Swierklaniec, 2017-01-17

Due to simple human mistake at final automatic assembly line, it may happen that Your HYDRA audio-video scart switch, may not output proper sound range. Hydra consists of 8 scart INPUTS and 1 scart OUTPUT. At each INPUT sockets, there are two capacitors, filtering incoming audio:

Difference between capacitors and schematic:

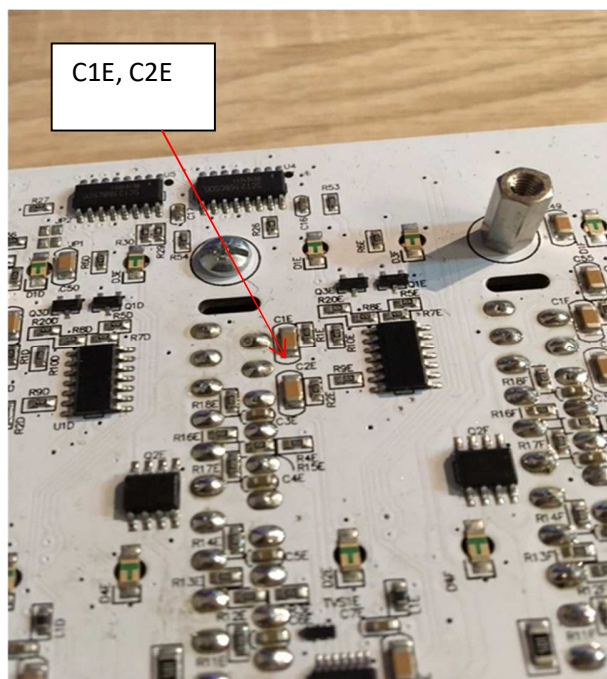
- Scart no 1: C1A,C2A
- Scart no 2: C1B, C2B
-
- Scart no 8: C1H, C2H

Problematic capacitors are largest ones – one below other. 2 pieces at each scart port. Height approx. 1mm.

Proper capacitors have approx. 5mm height. Cost for 100 pieces – 2Euros

1. Obtain **SMD 10uF 1206** size capacitors or contact me – I will send for free
2. Disconnect HYDRA power supply
3. Desolder 8 x 2 capacitors (16 pieces - two for each scart port) using proper tools.
4. Clean pads from solder
5. Solder proper capacitors

Please, test sound output at each scart socket.
